# 42 Honeysuckle Drive

State Significant Development (SSD-10378)

DEVELOPMENT MODIFICATIONS

March 2022

# 6.1 Design Changes

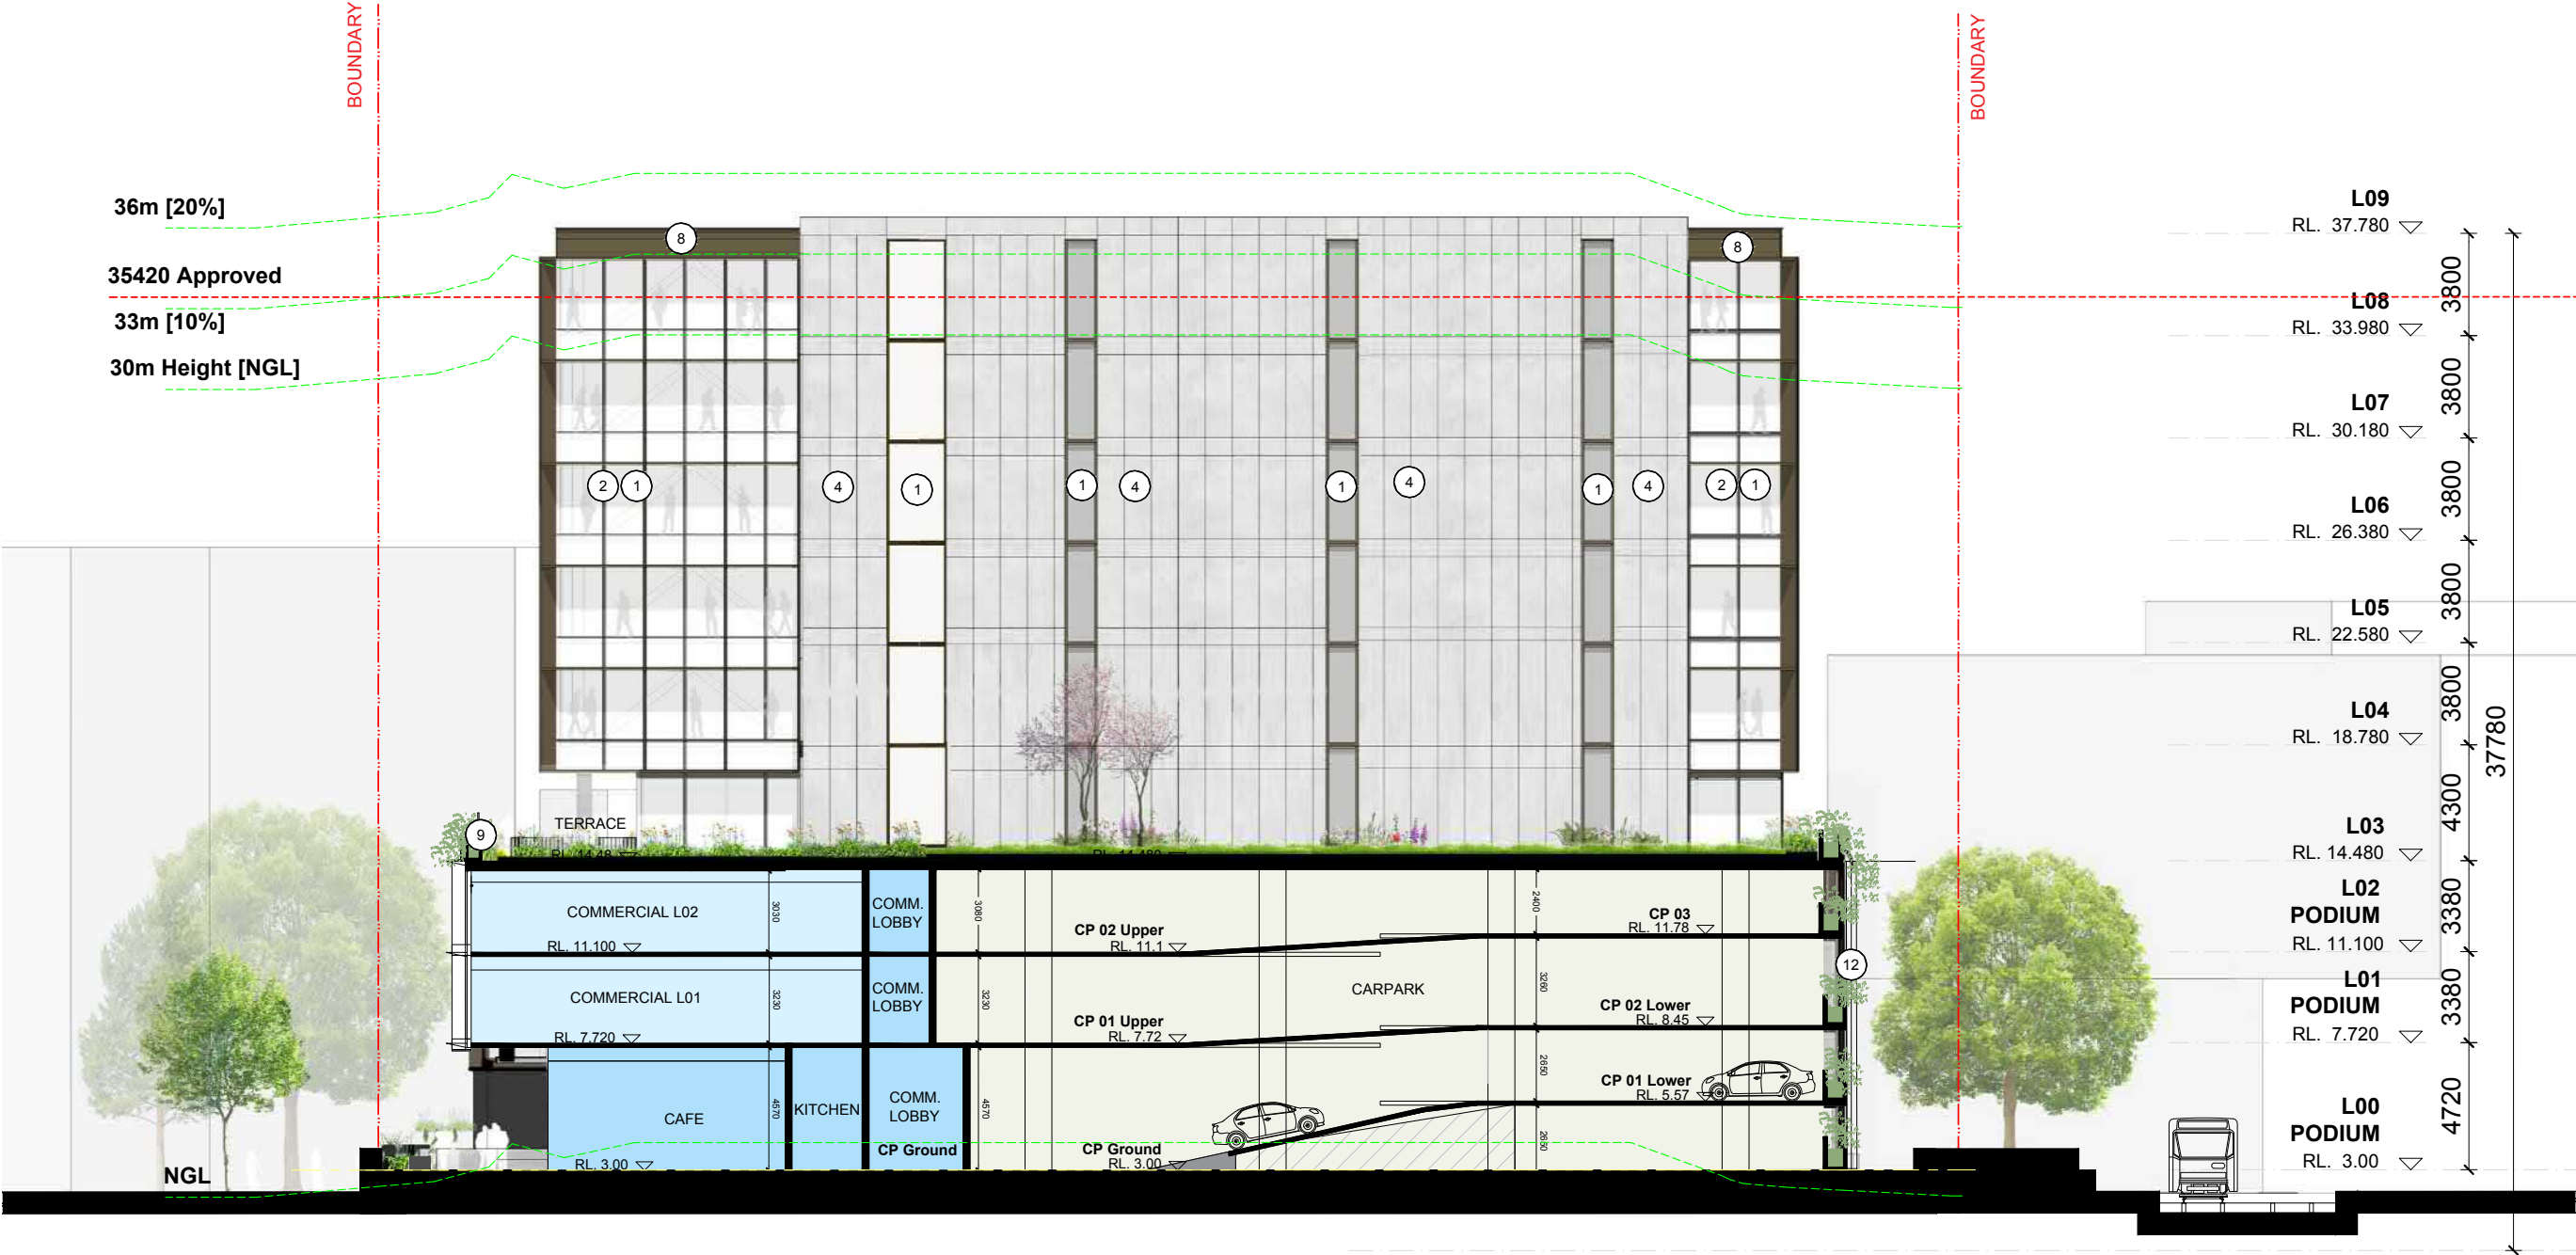
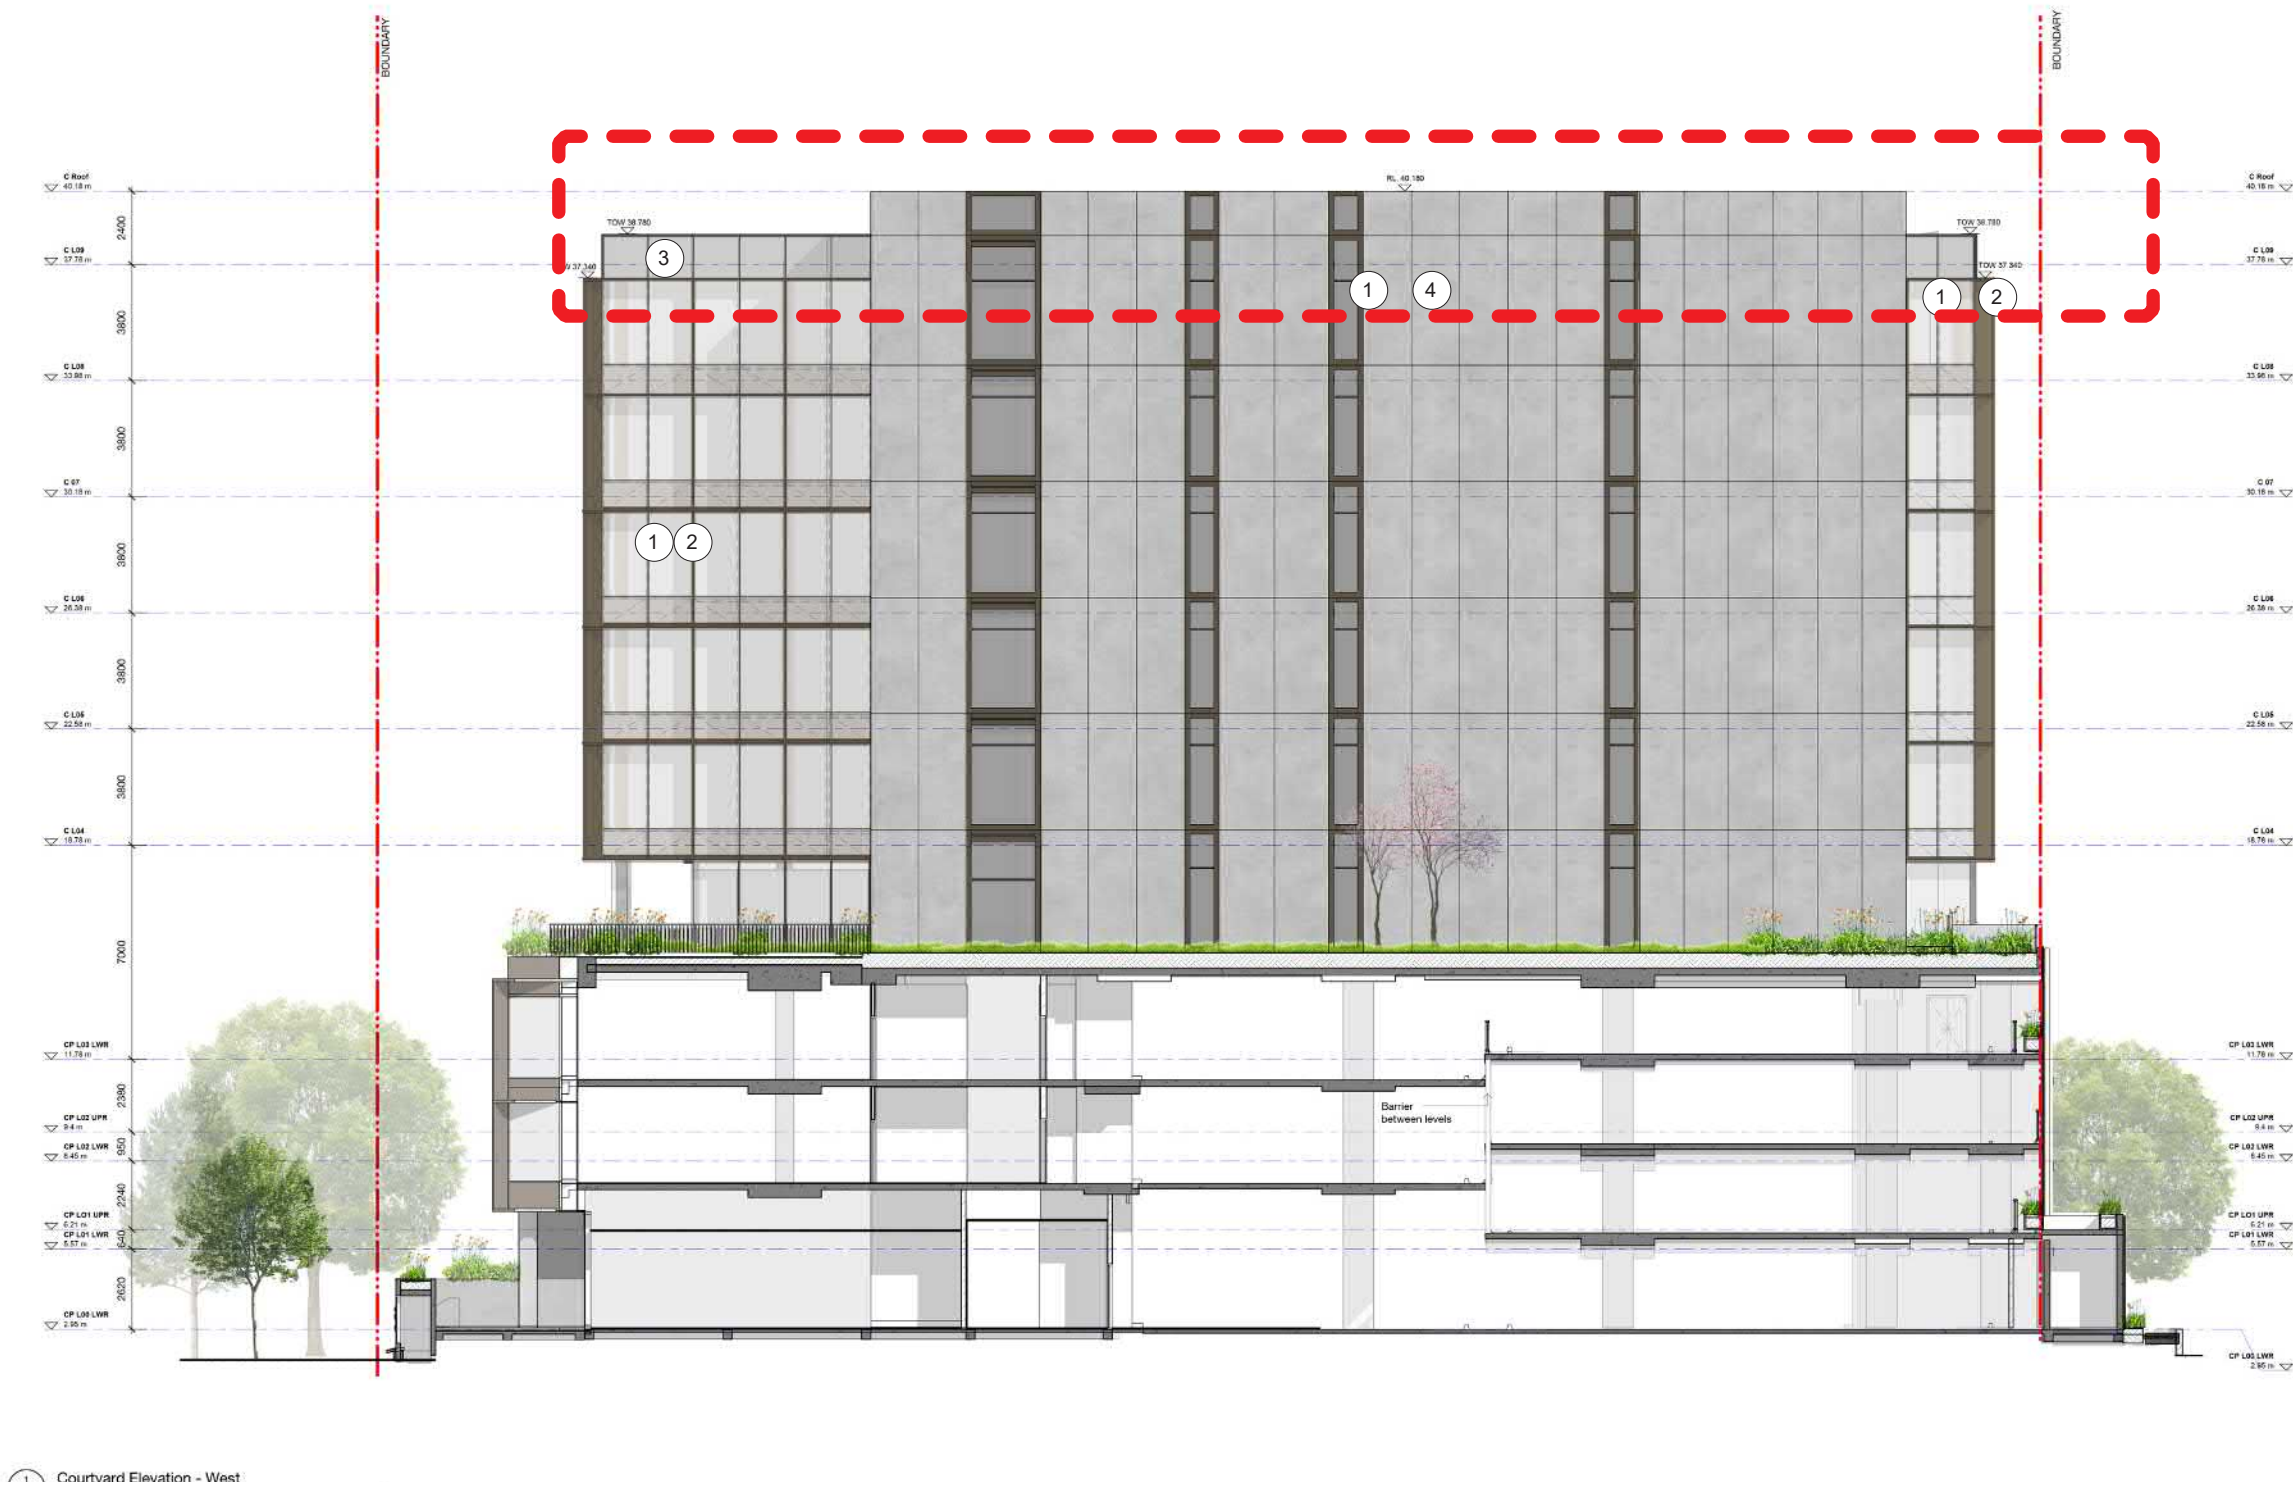
1 / Commercial tower height increased by 600mm to allow for additional plant height.

2/ Facade colours and materiality remain the same
